SUBJECT: AMENDMENT NO. 105 TO FACILITY OPERATING LICENSE NO. NPF-58 - PERRY  
 NUCLEAR POWER PLANT, UNIT 1 (TAC NO. MA3487)

SAFETY EVALUATION BY THE OFFICE OF NUCLEAR REACTOR REGULATION  
RELATED TO AMENDMENT NO.105 TO FACILITY OPERATING LICENSE NO. NPF-58

PERRY NUCLEAR POWER PLANT, UNIT 1

FIGURE 1 - EXISTING FWLCS CONFIGURATION

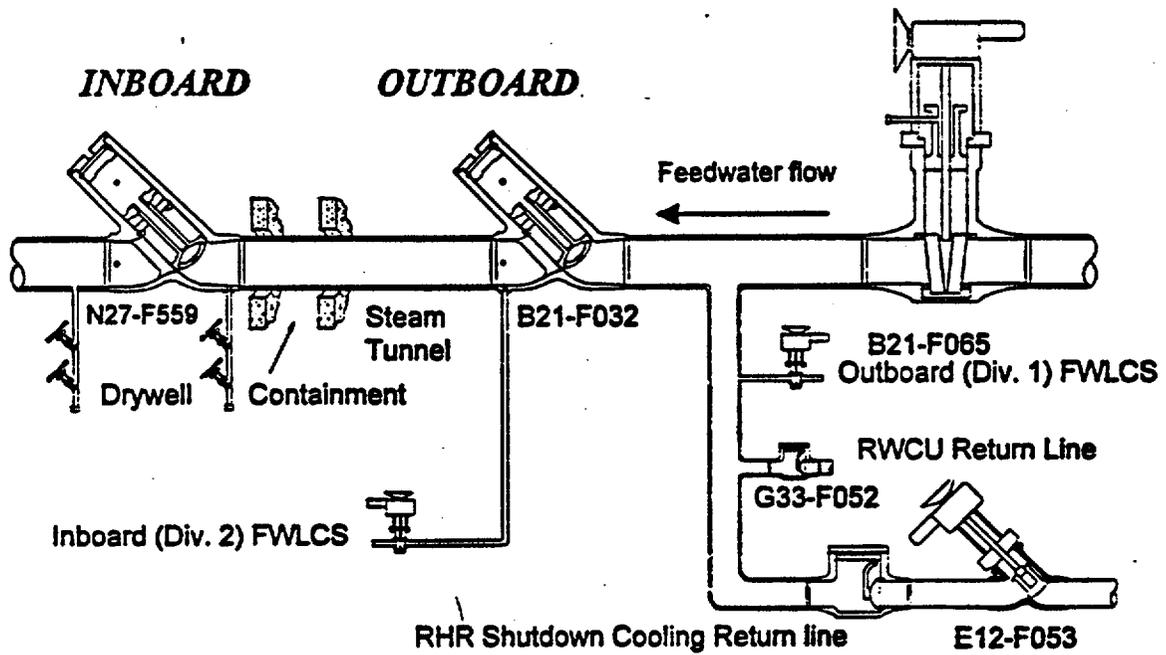
The current Perry feedwater penetration and isolation provisions are shown in Figure 1. (It should be noted that there are two feedwater penetrations designated train A and B. However, for simplicity, Figure 1 only lists the valve numbers and does not provide the train A and B designations.) Each feedwater line penetrating containment has three containment isolation valves. Two piston lift-style check valves, located both immediately inside and outside the containment penetration, are in each feedwater line for isolation of significant flow from a feedwater line break outside containment. These anti-waterhammer check valves are not designed for air tests at low pressures. A third valve (a remote manual motor-operated gate valve), located outside containment upstream of the outside check valve, is provided for long-term, high integrity leakage protection when, in the judgment of the operator, continued make-up from feedwater is unnecessary or is not available. There is no automatic isolation of the feedwater lines based on accident signals, so that feedwater flow can be maintained to the reactor vessel. As noted in ANS-56.2/N271-76, "Containment Isolation Provisions for Fluid Systems," greater plant safety is maintained with a feedwater supply to the reactor.

The current licensing basis for feedwater isolation relies on the FWLCS to establish a water seal between the three containment isolation valves approximately one hour following an accident. Successful operation of the FWLCS relies upon operator action to close the MOV and initiate the FWLCS approximately 20 minutes following the accident. The feedwater check valves must be essentially leak tight so that the injected water from the FWLCS can establish a water seal. The check valves are leak tested during every refueling outage and have an acceptance criteria of 1 gpm water leakage. If leakage exceeds this limit, a water seal may not be established due to limitations of flow from the FWLCS makeup pumps.

Operational experience has not always demonstrated that the feedwater check valves are leak tight. "As-found" testing over the last several refueling outages has shown that the check valves leak in excess of 1 gpm and actual values have been on the order of 4-14 gpm. Whenever leakage exceeds allowable limits, the licensee is required to take corrective actions to restore valve integrity to the licensing limits. This requirement has led to excessive costs and man-rem exposures. During the sixth refueling outage, the licensee estimated that valve restoration cost approximately \$880,000 and 5 man-rem exposure. More importantly, however, is the concern that due to excessive check valve leakage, the existing FWLCS may not be capable of performing its safety-related function.

FIGURE 2 - PROPOSED FWLCS CONFIGURATION

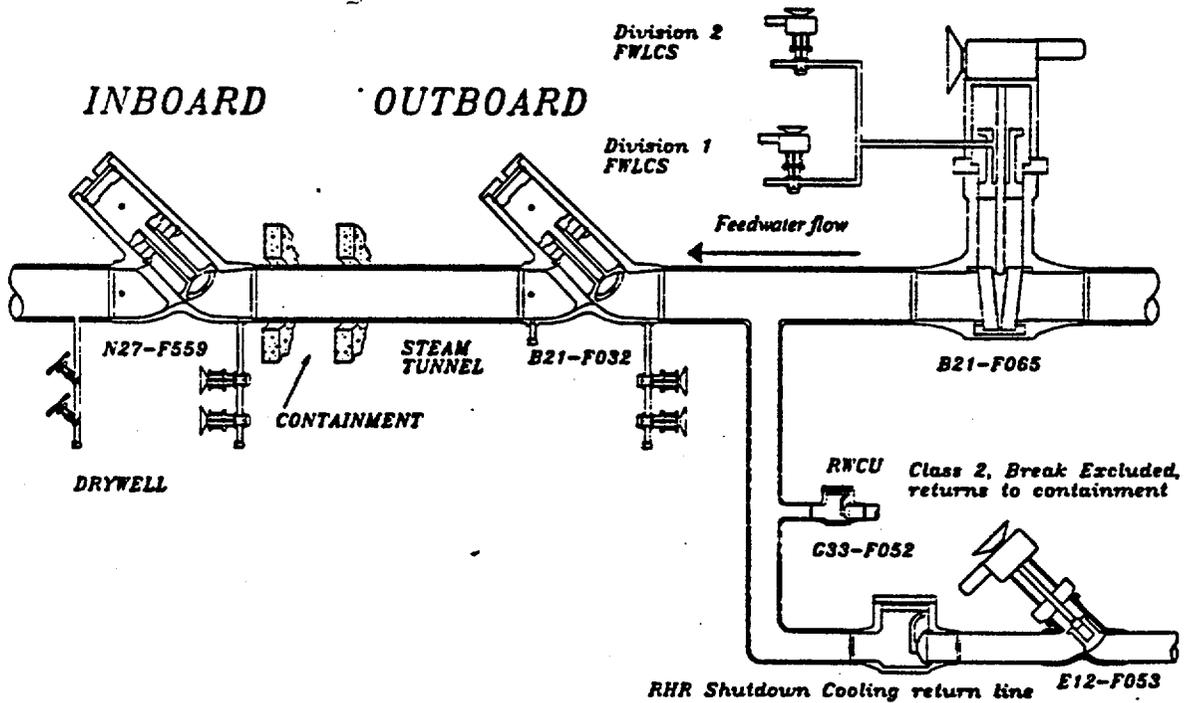
In the proposed design, as shown in Figure 2, both independent trains of the FWLCS will be routed to the bonnet area of each existing feedwater MOV. To allow the FWLCS to seal the 20" gate valves, the FWLCS will be supplied to an existing ½"-threaded connection in the packing area of the valve bonnet. Once in the bonnet area of the 20" gate valve, the FWLCS seal water flows around the wedge-shaped gate into the area between the two hardfaced mainseats in the

Once the FWLCS is rerouted to the stem and bonnets of the MOVs in lieu of the feedwater piping volume, branch lines off of the feedwater line need a different licensing basis for leakage mitigation (See Figure 2). These lines no longer have a water seal since the FWLCS will no longer be used to fill the feedwater piping between the isolation valves.

As described above, the staff has concluded that containment isolation valves in branch lines leading to the feedwater piping will be appropriately treated through Appendix J to 10 CFR Part 50 and the licensee's Primary Coolant Sources Outside Containment program. Therefore, the staff concludes that the containment isolation provisions for the branch lines are acceptable.
